This is a preliminary review there may be other red lines and other items that may need to be addressed when project goes to final review.

Fenster Farms Subdivision Phase 4

Fenster Farms Subdivision Phase 4
PART OF THE SE QUARTER OF SECTION 7, T.6N., R.2W., S.1B. & M., U.S. SURVEY
WEBER COUNTY, UTAH

Preliminary Plan

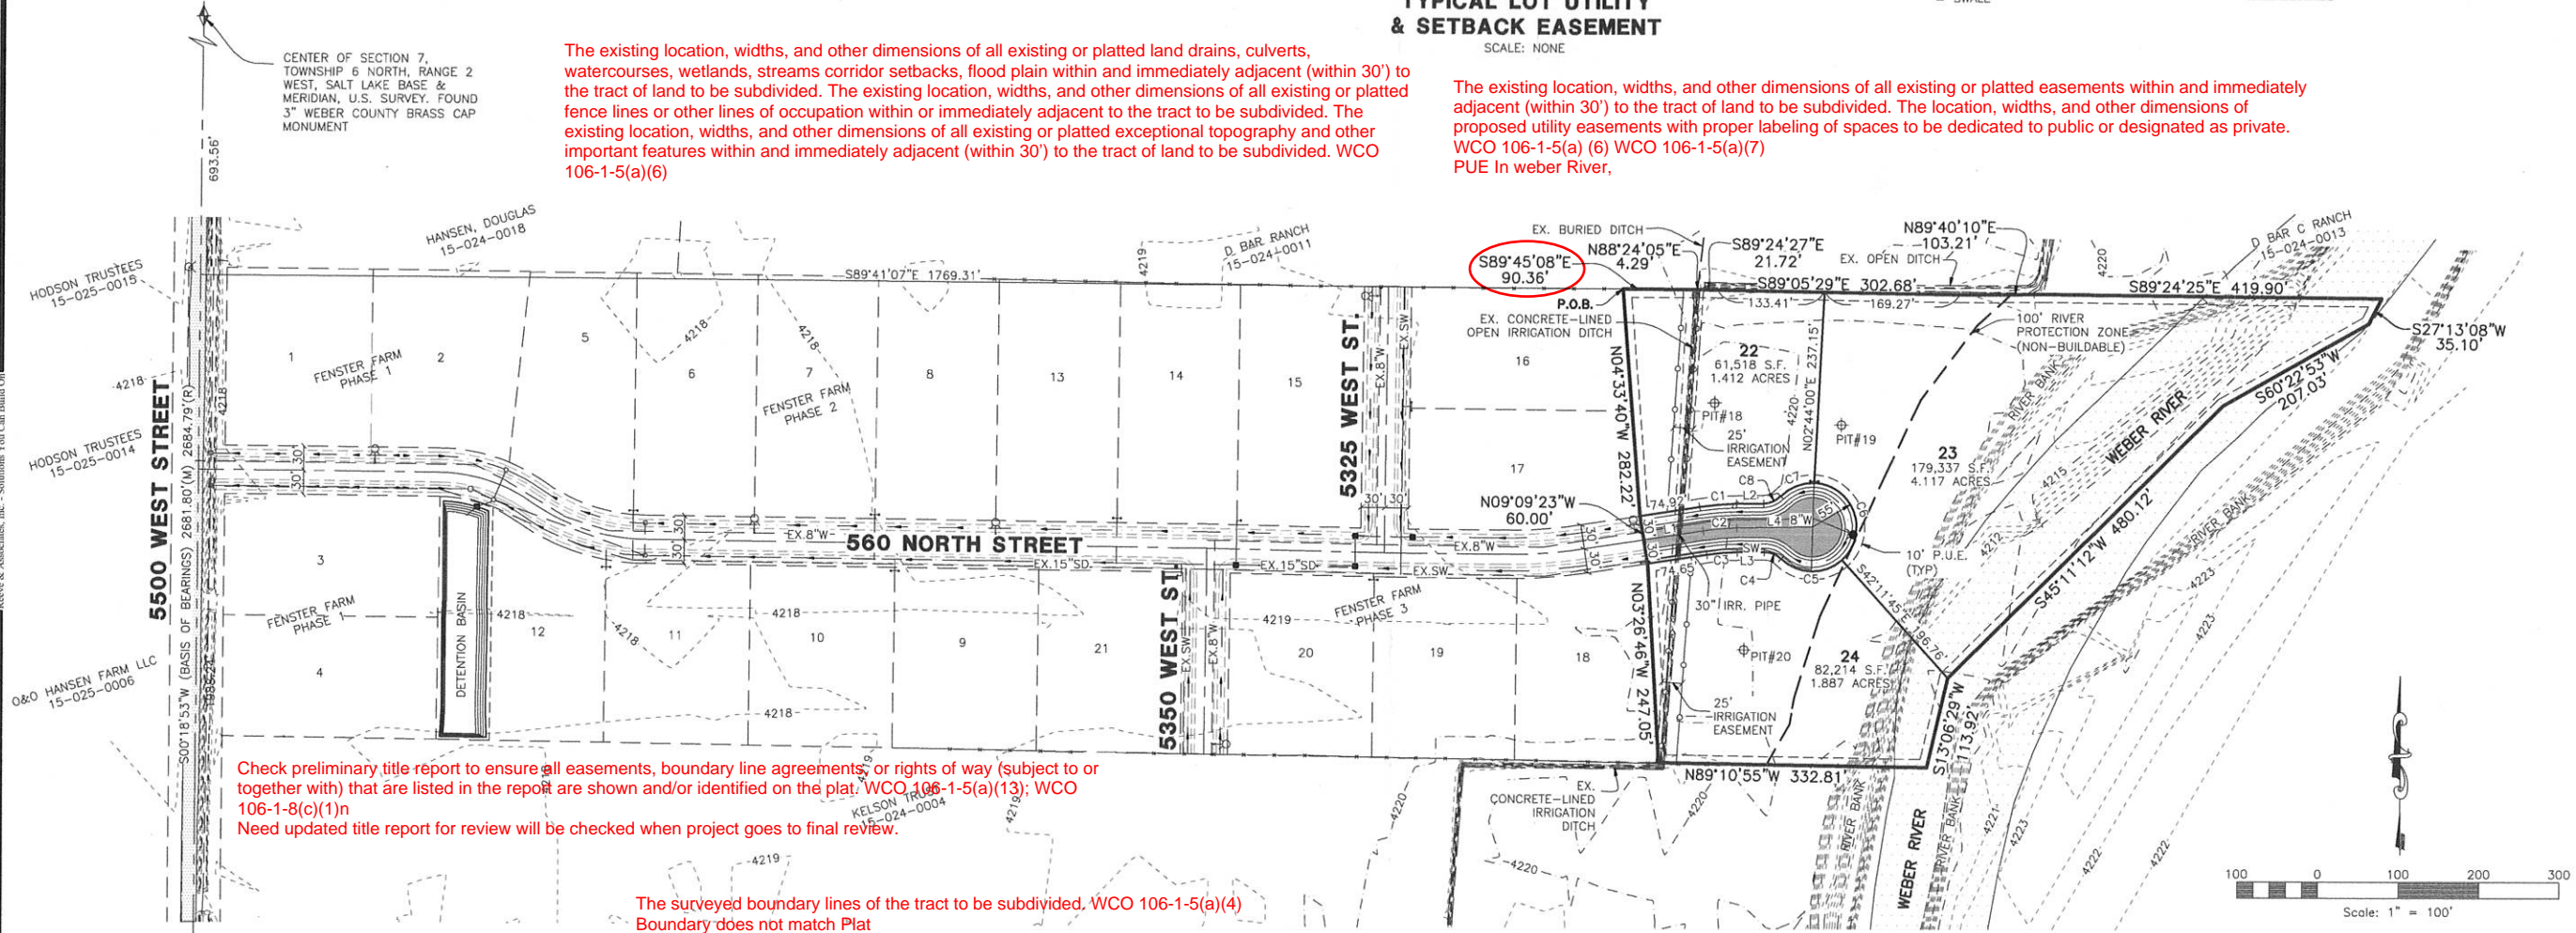
The existing location, widths, and other dimensions of all existing or platted land drains, culverts, watercourses, wetlands, streams corridor setbacks, flood plain within and immediately adjacent (within 30') to the tract of land to be subdivided. The existing location, widths, and other dimensions of all existing or platted fence lines or other lines of occupation within or immediately adjacent to the tract to be subdivided. The existing location, widths, and other dimensions of all existing or platted exceptional topography and other important features within and immediately adjacent (within 30') to the tract of land to be subdivided. WCO 106-1-5(a)(6)

The existing location, widths, and other dimensions of all existing or platted easements within and immediately adjacent (within 30') to the tract of land to be subdivided. The location, widths, and other dimensions of proposed utility easements with proper labeling of spaces to be dedicated to public or designated as private. WCO 106-1-5(a) (6) WCO 106-1-5(a)(7) PUE In weber River,

Check preliminary title report to ensure all easements, boundary line agreements or rights of way (subject to or together with) that are listed in the report are shown and/or identified on the plat. WCO 106-1-5(a)(13); WCO 106-1-8(c)(1)n
Need updated title report for review will be checked when project goes to final review.

The surveyed boundary lines of the tract to be subdivided. WCO 106-1-5(a)(4)
Boundary does not match Plat

Subdivision Name approved by the county recorder. Subdivision name in bold letters at top of sheet. General location of subdivision in bold letters at top of the sheet. The township, range, and quarter section of the subdivision in bold letters at the top of the sheet. Date of the survey noted in the heading (Meaning the date, year and month the survey markers were placed). WCO 106-1-5(a)(1); WCO 106-1-8(c)(1)a; UCA 17-27a-603(1)(a)
